CITY OF CHARLOTTESVILLE **BOARD OF ARCHITECTURAL REVIEW** STAFF REPORT

Certificate of Appropriateness

BAR 22-06-06

0 Preston Place, TMPs 050118001 and 050118002

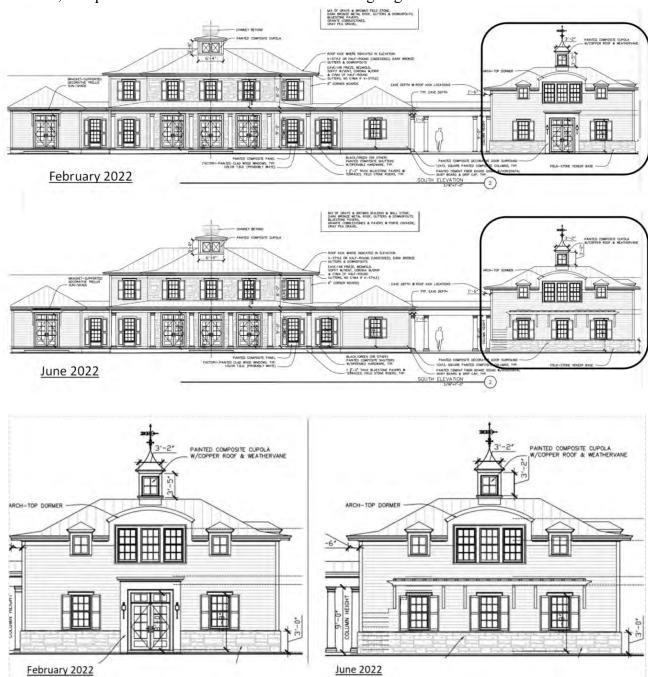
Regarding the site, staff is concerned that a substantial amount of the front yard is consumed by the driveway and parking area. Chapter II of the Design Guidelines (Site Design & Elements) recommend placing parking in the rear:

<u>Staff Comment:</u> Staff recommends the BAR consider alternate driveway layouts that would minimize impact on the front yard.
